GOVERNMENT OF THE DISTRICT OF COLUMBIA
DEPARTMENT OF TRANSPORTATION

MEMORANDUM

SUBJECT: ZC Case No. 15-22 – 301 Florida Ave NE

Figure 1 Site Design and Access (Source: DEP)

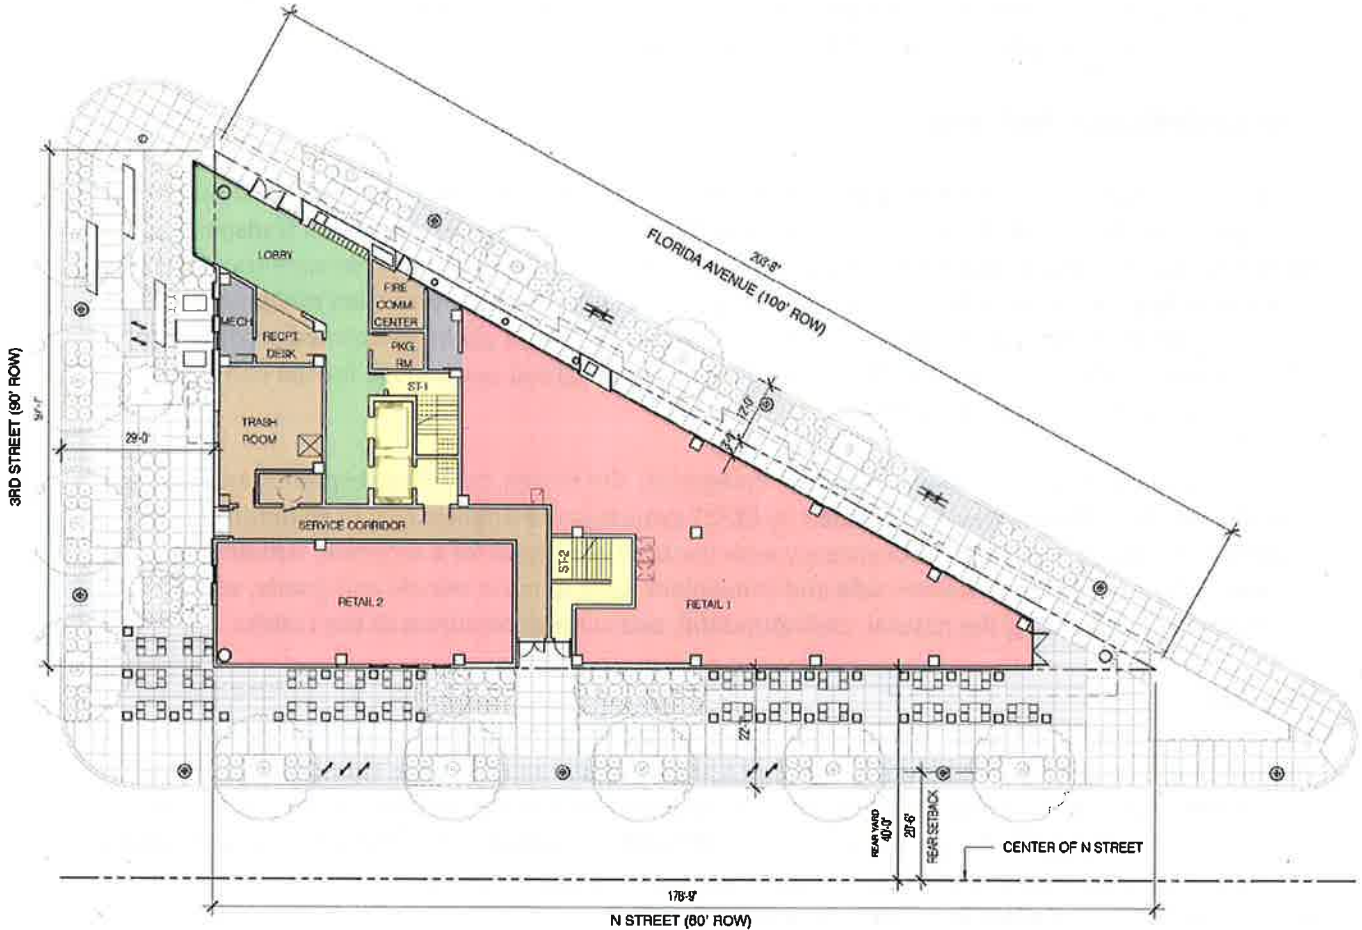
As noted above, no on-site loading facilities are proposed. Instead, loading is proposed to occur from the N Street or 3rd Street curbside. The ground floor of the project is designed with service corridor access to both streets to facilitate curbside loading and trash pick-up. Florida Avenue does not include any space for curbside uses such as parking or loading, and therefore there are no opportunities to load from Florida Avenue.

While not explicitly stated, the final element of the plan indicates that the Applicant plans to apply for a curbside loading zone. A curbside loading zone requires an application to DDOT, and no application has been submitted at the time of this report. DDOT would evaluate any potential application to determine the appropriateness of establishing a curbside loading zone in the vicinity. Of note, curbside loading zones are for commercial loading activity only and not intended for residential loading activity. Should a curbside loading zone not be granted, loading could occur in open curbside space along N Street or 3rd Street. DDOT's preference is that loading occur from N Street because it is a lower volume street and is likely to generate fewer operational issues. As discussed in the Streetscape and Public Realm section below, any potential changes to N Street must account for loading activity. In addition, emergency No Parking Signs are available from DDOT to create temporary loading areas on the curbside.

- Vault: Preliminary site plans show a utility vault in the public space along 3rd Street. DDOT's approach to utility vaults is to allow vaults in public space only when they cannot be located on private property. If located in public space, vaults must be surrounded by landscaping on at least three sides, as shown in the preliminary public space plans. The Applicant will need to coordinate with DDOT on the final vault location and treatment during the public space permitting process.

- Sidewalk widths: Sidewalk widths along all adjacent streets should be a minimum of 8 feet wide, with a preference for 10 feet wide on Florida Avenue depending on the availability of right-of-way.
- Special paving: The amount of special paving along the N Street frontage exceeds the amount of special paving that is typically permitted and will need to be reduced.
- Canopies: The Applicant's plans show a series of canopies extending along a significant portion of the Florida Avenue building façade. The canopies, as shown, likely do not meet regulations for canopies and may require a modification from the Building Code. The final design of the canopies will be addressed during permitting.

DDOT finds that the loading management plan with revisions eliminating references to a curbside loading zone will sufficiently address loading impacts.
